**Port Stephens
Local Traffic Committee Minutes**

**Meeting held in the Port Stephens Council Committee room and via Zoom on
Tuesday 3rd December, 2024 at 9:30am**

PROJECT: Birubi Aboriginal Place - Event Management

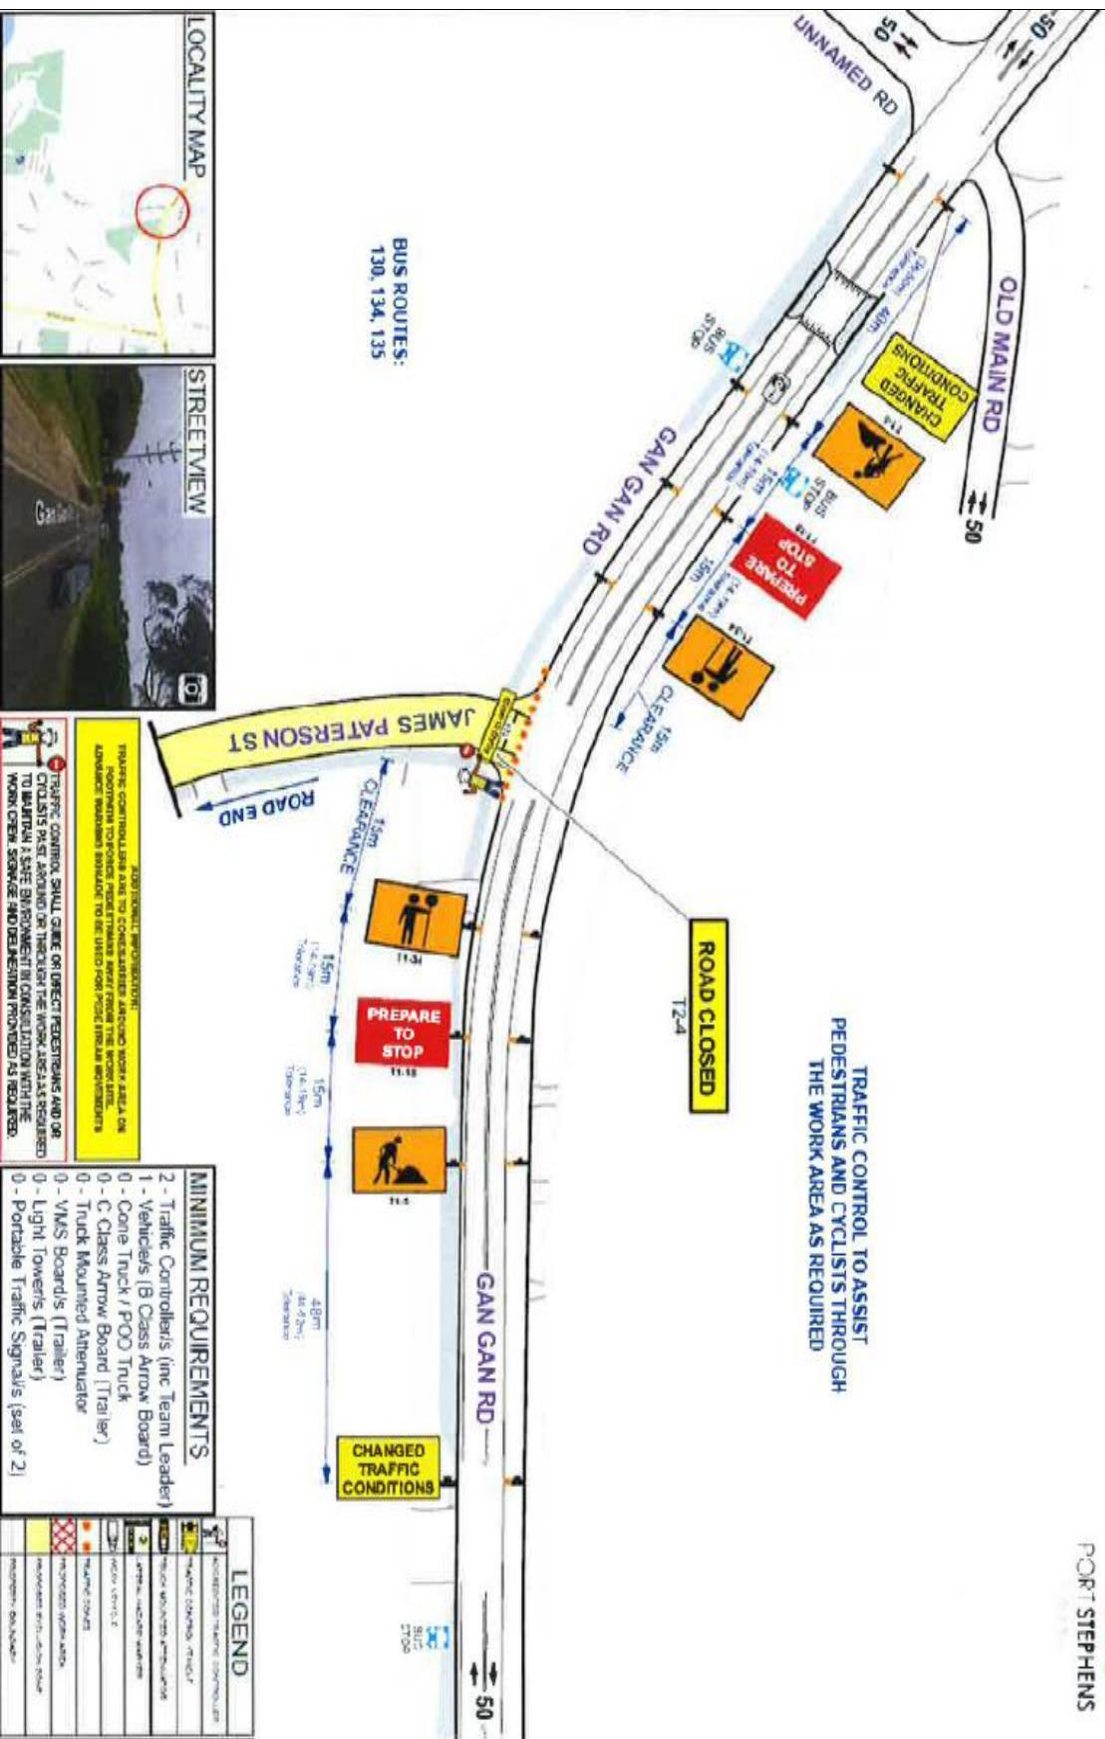
Temporary parking controls include extended 'No Parking' along the eastern side of James Paterson Street. Council is seeking the endorsement of the Event Management Plan for ongoing use at Birubi during future peak holiday periods which will include:

Equipment required: 'No Parking - 6am-6pm'
No Stopping

William Street, Karuah - Request for 'No Stopping' restrictions

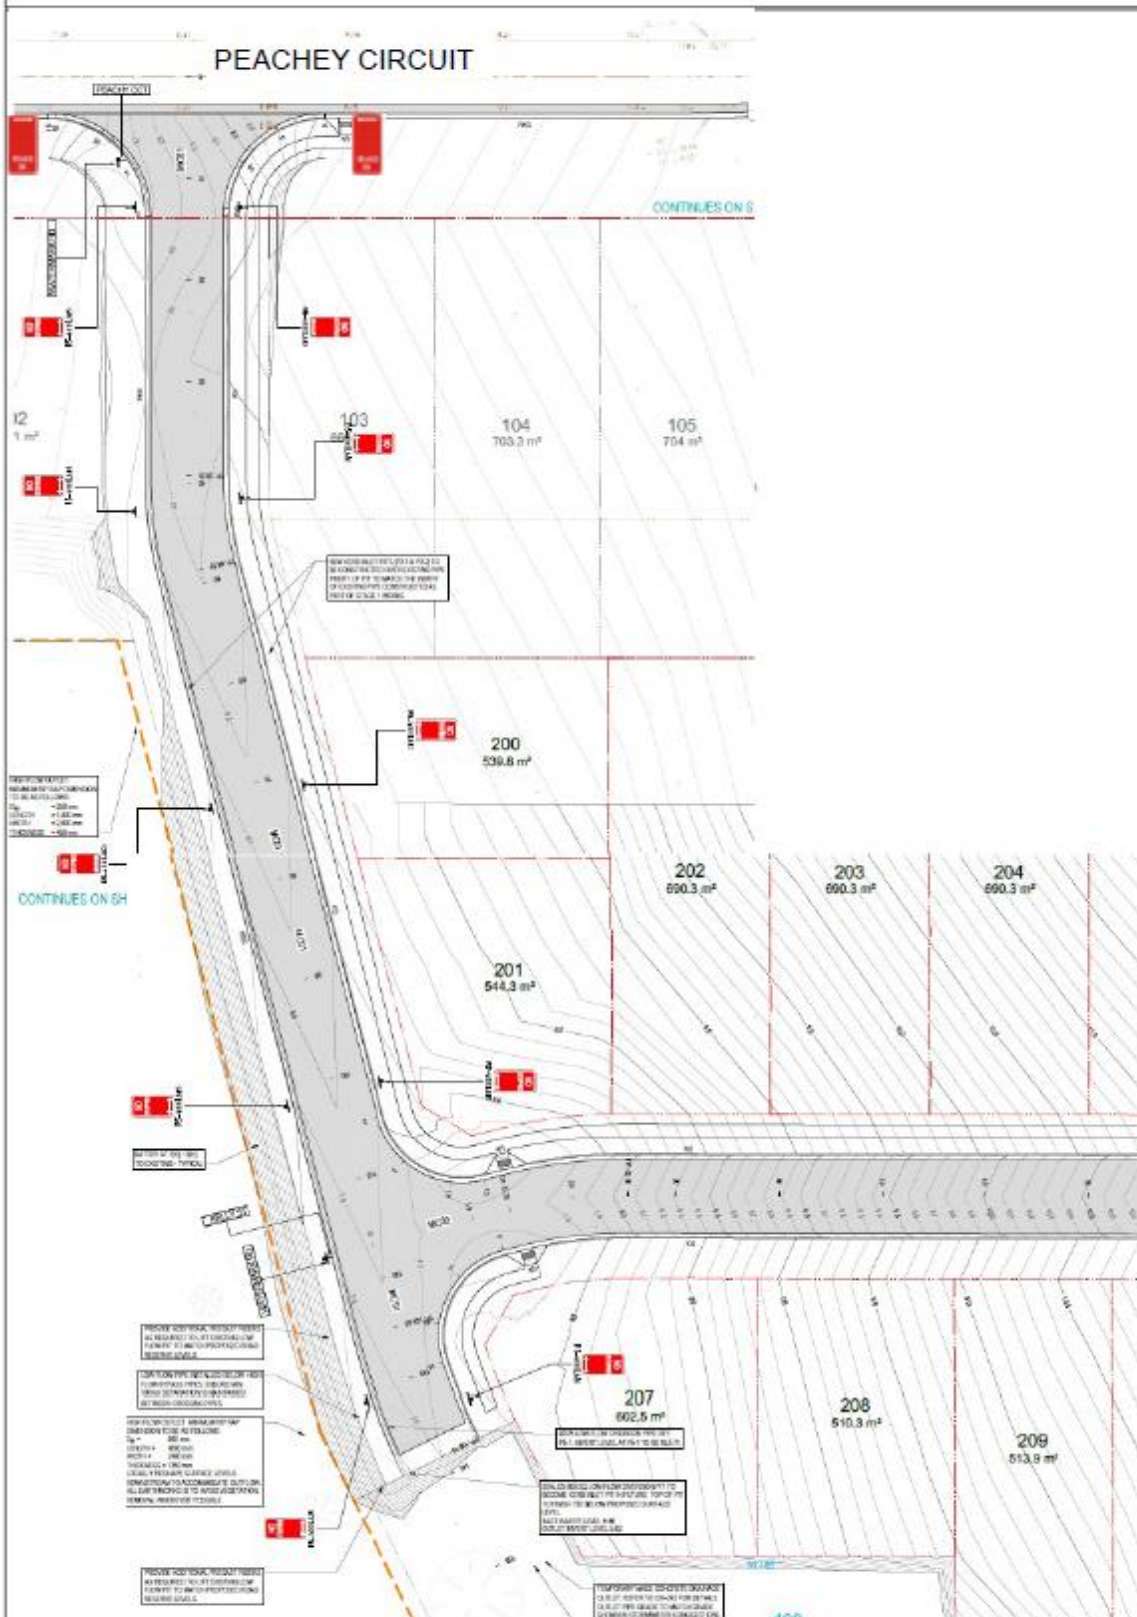
The requirement is for 'No Stopping' along both sides of the unnamed access road, connecting to Peachey Circuit.

Committee members requested that 'No Stopping' signs be added in Peachey Circuit to indicate the end point of the restrictions.

Approve installation of 'No Stopping' restrictions in William Street Karuah, as shown on the attached sketch, Annexure A.
